**Subject: Clarification of NFS' Responses to the RAI Supporting NRC's Environmental
Review for the BLEU Project**

***Clarification of NFS' Responses to the Request for Additional Information
Supporting NRC's Environmental Review for the BLEU Project***

Updated Drawing Including Locations for Former Wells SC-7 and 82

Figure A-33a

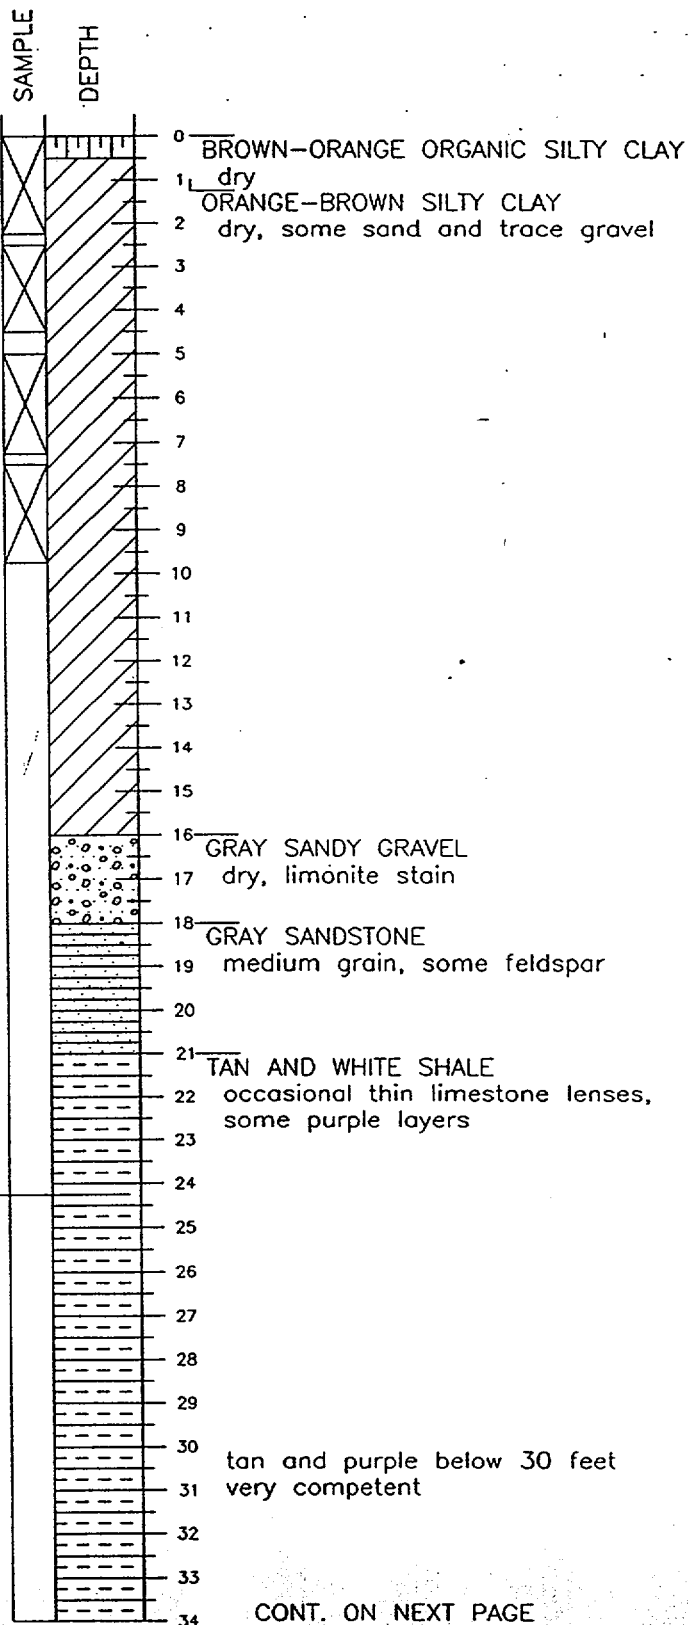
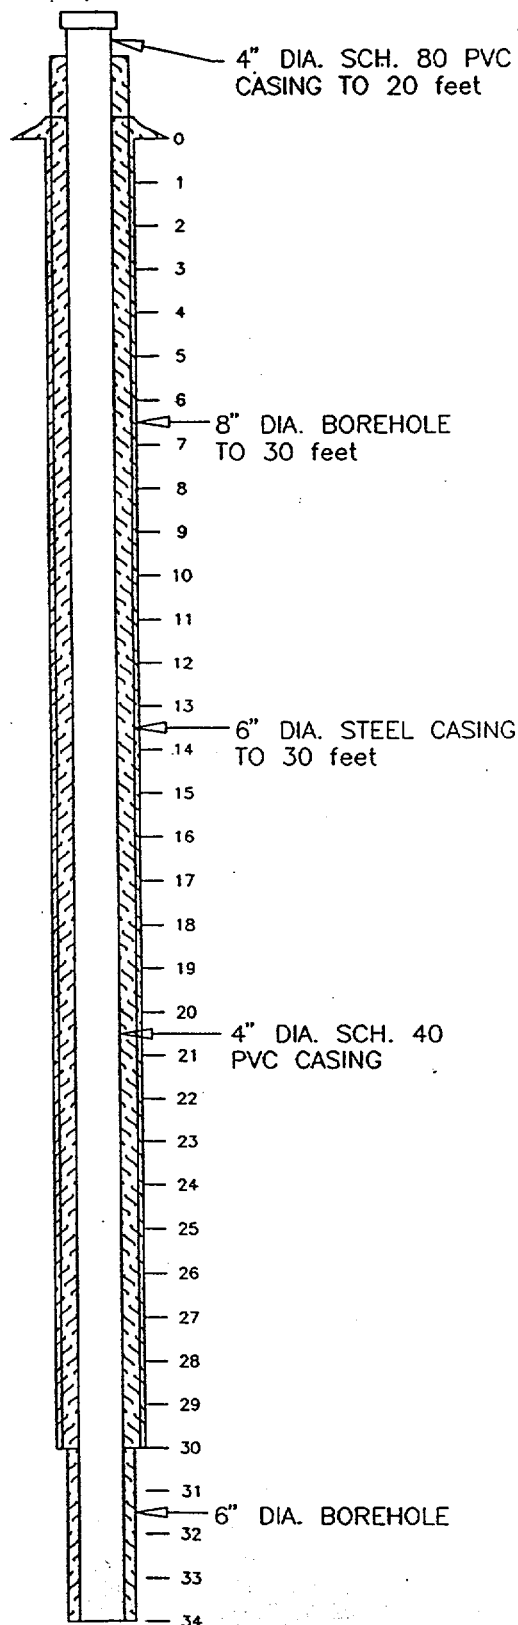
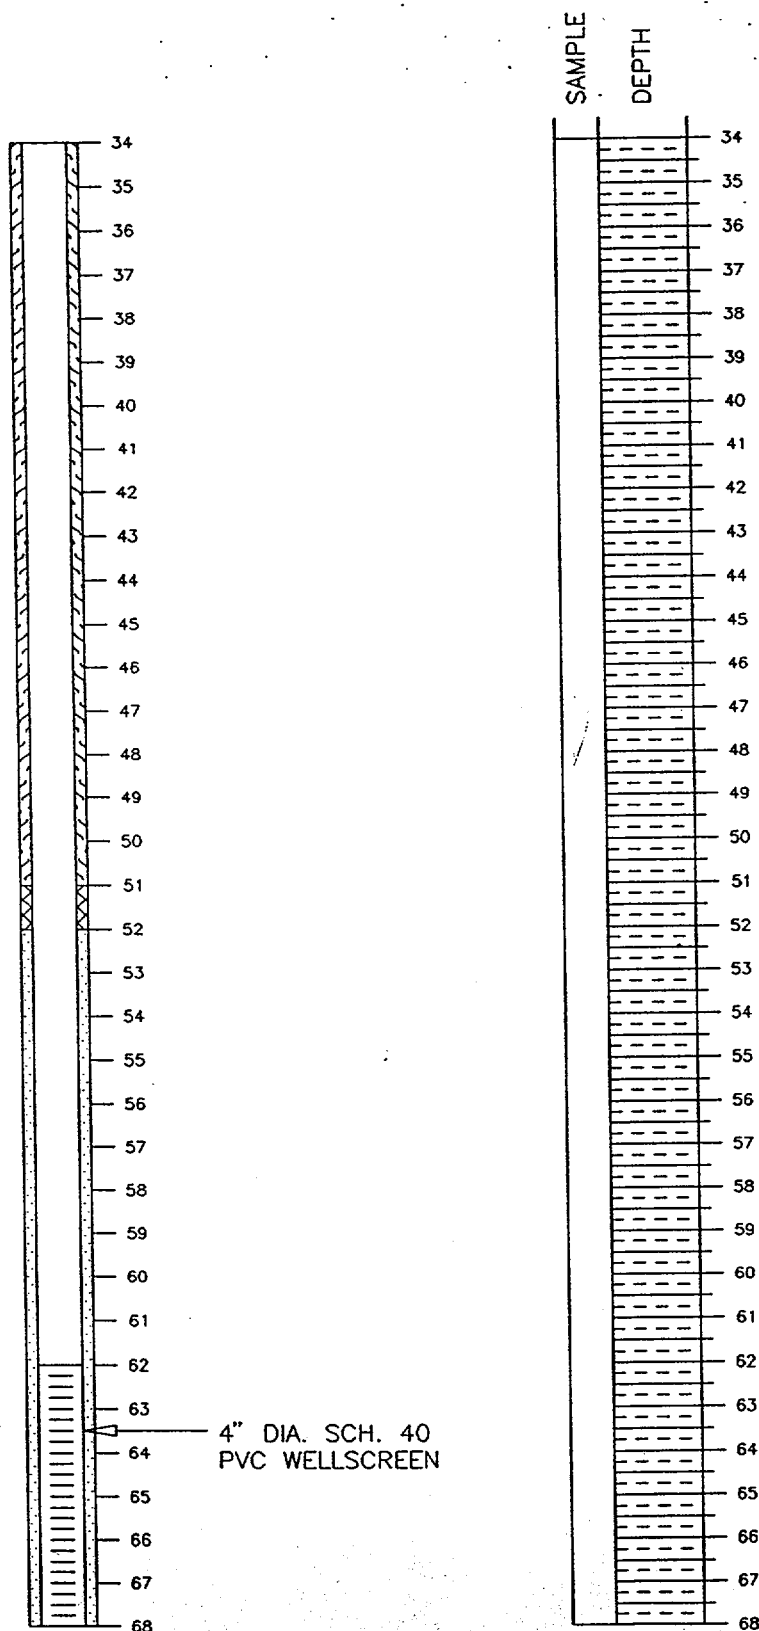
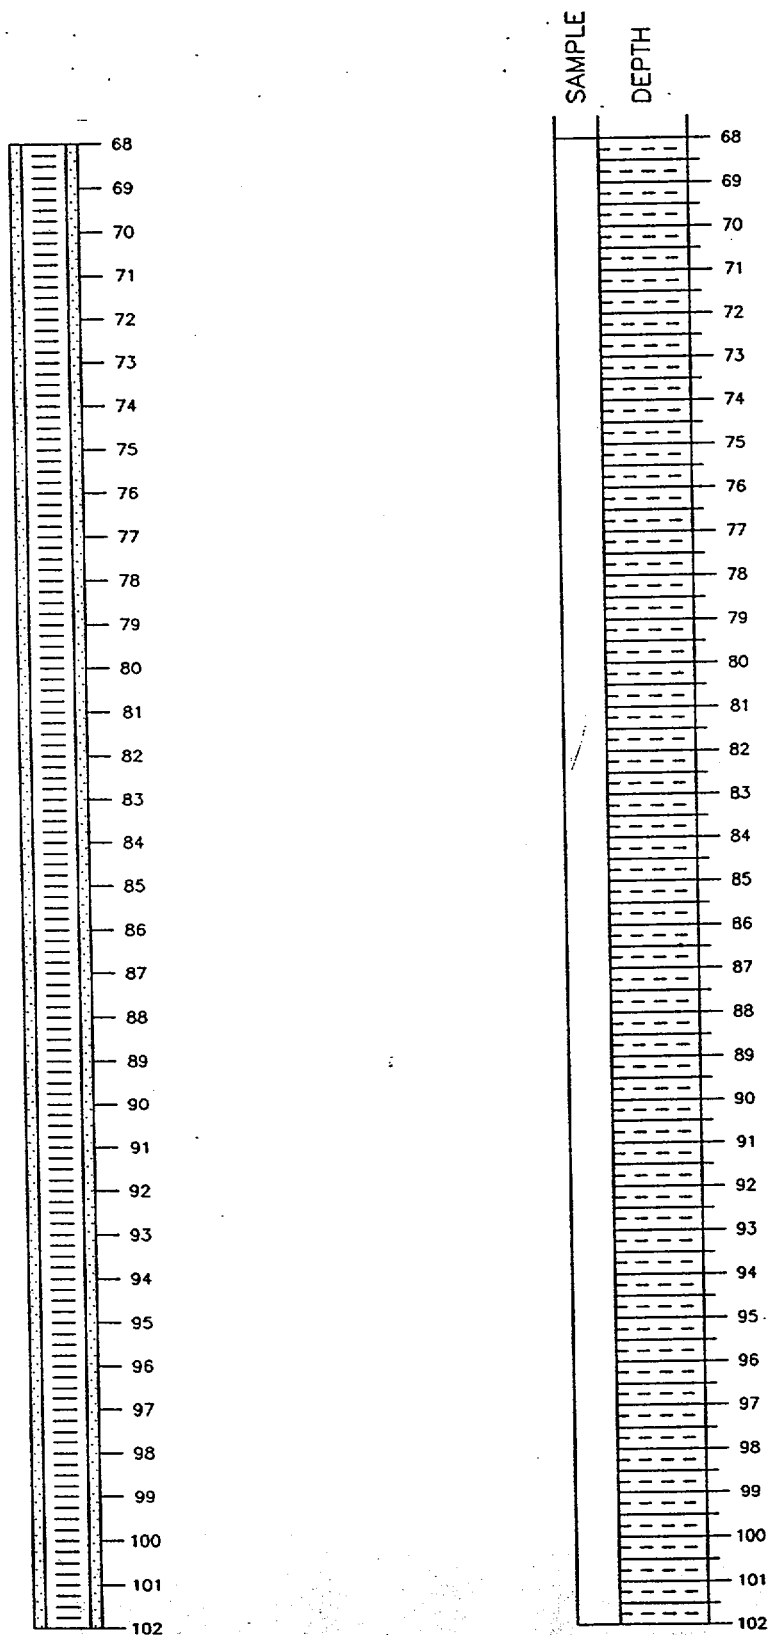
NRC Comment 3: (RAI 21) Information on the hydrology at the proposed BLEU Complex location that was discussed during the last meeting was not included in the RAI package. This includes zone depths, water levels, brief info generally describing that a baseline characterization would be done. NFS agreed to provide.

NFS Response to Comment 3: Attachment III of this submittal provides boring logs, well installation diagrams, and water level data for wells SC-7 and 82 that were located on the proposed BLEU Complex site. A description of the baseline characterization is provided in the response to Comment 5.
